CHEVY COLORADO/GMC CANYON SIDE RAIL INSTALLATION

The Original
TRUXEDO
Patented
P/N 1115963 Rev. B

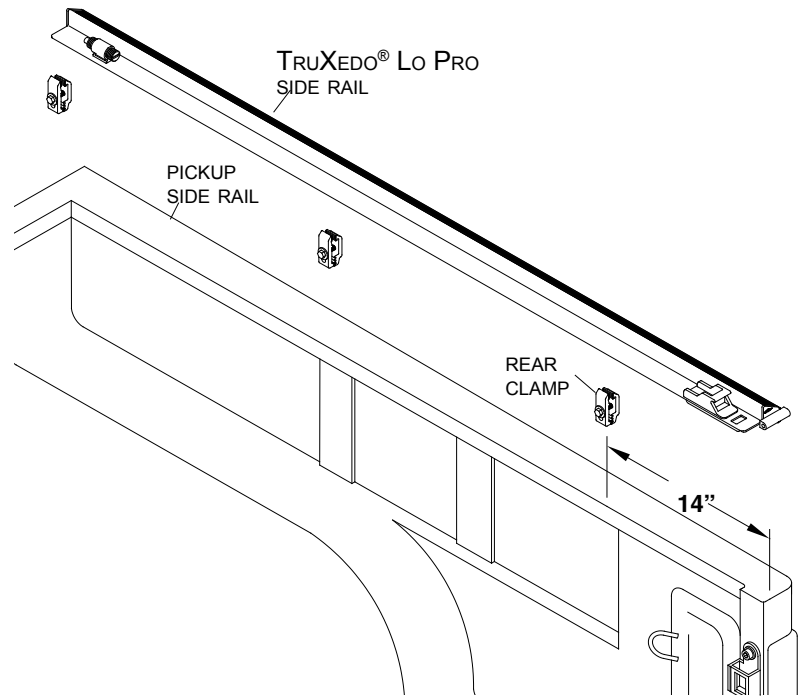
It is not possible to fasten the rear clamps 8" from the tailgate, as shown in the Owner's Manual, because of the contour of the pickup bed rails.

Follow the Owner's Manual instructions to install side rails on your Chevy Colorado or GMC Canyon pickup with this exception: Install the rear clamps 14" in front of the tailgate.

CHEVY COLORADO/GMC CANYON SIDE RAIL INSTALLATION

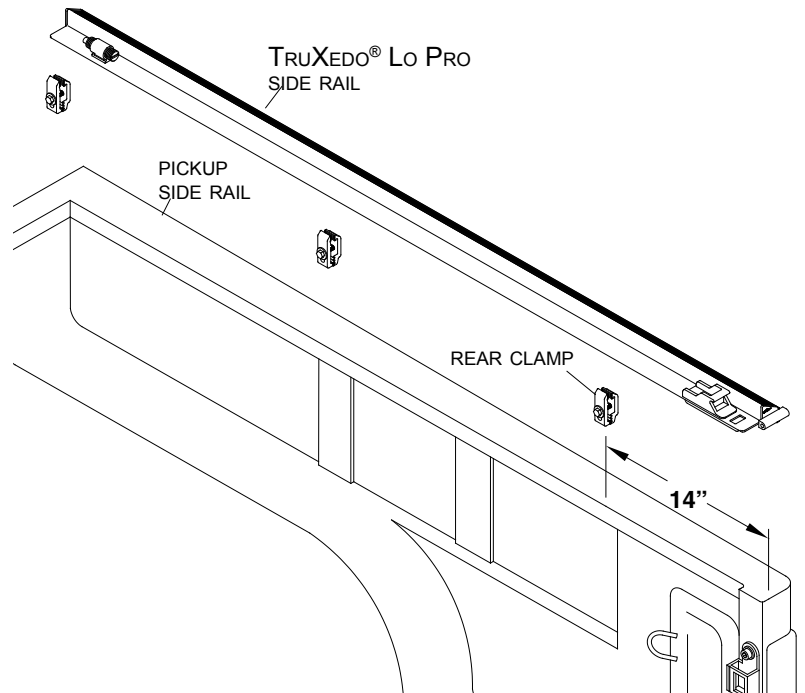
It is not possible to fasten the rear clamps 8" from the tailgate, as shown in the Owner's Manual, because of the contour of the pickup bed rails.

Follow the Owner's Manual instructions to install side rails on your Chevy Colorado or GMC Canyon pickup with this exception: Install the rear clamps 14" in front of the tailgate.
